Proposal #22: 4050-23-71, WISC 2022303
Fond du Lac-Chilton
Drainage Way Culvert Replacement
USH 151
Fond du Lac County

This is Addendum No. 01, which provides for the following:

Addendum No. 01
 ID 4050-23-71
 Revised Sheet 9
 March 29, 2022

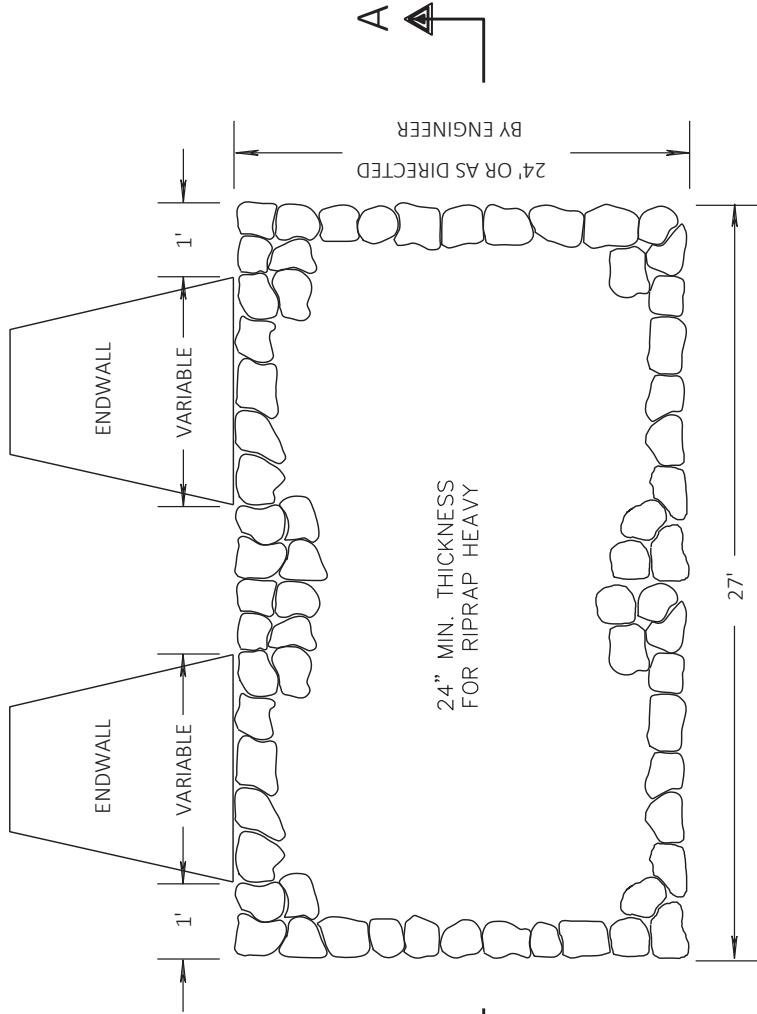
Revised Plan Sheets	
Plan Sheet	Plan Sheet Title (brief description of changes to sheet)
8	Corrected the Station locations for this construction detail to show STA 444+61 LT, STA 444+75 RT, STA 459+64 LT and STA 459+53 RT.
9	Corrected the Station location for this construction detail to show STA 466+99 RT and STA 467+29 LT
17	Corrected Category 0010 quantity for items 606.0200 Riprap Medium, 606.0300 Riprap Heavy, 645.0120 Geotextile Type HR
22	Revised to add riprap on the upstream side of a pipe at STA 444+67 RT
24	Revised to add riprap on the upstream side of a pipe at STA 467+26 RT
26	Revised to add riprap on the upstream side of a pipe at STA 479+85 RT

STA 466+99 RT
 STA 467+29 LT

Addendum No. 01
 ID 4050-23-71
 Added Sheet 9A
 March 29, 2022

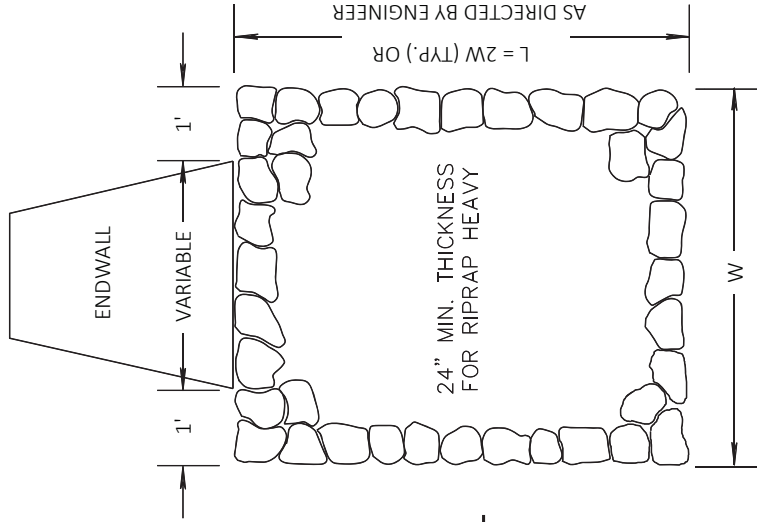
Added Plan Sheets	
Plan Sheet	Plan Sheet Title (brief description of why sheet was added)
9A	Added a construction detail for riprap heavy treatment at culverts at STA 479+60 LT and STA 480+09 RT

STA 479+60 LT
 STA 480+09 RT
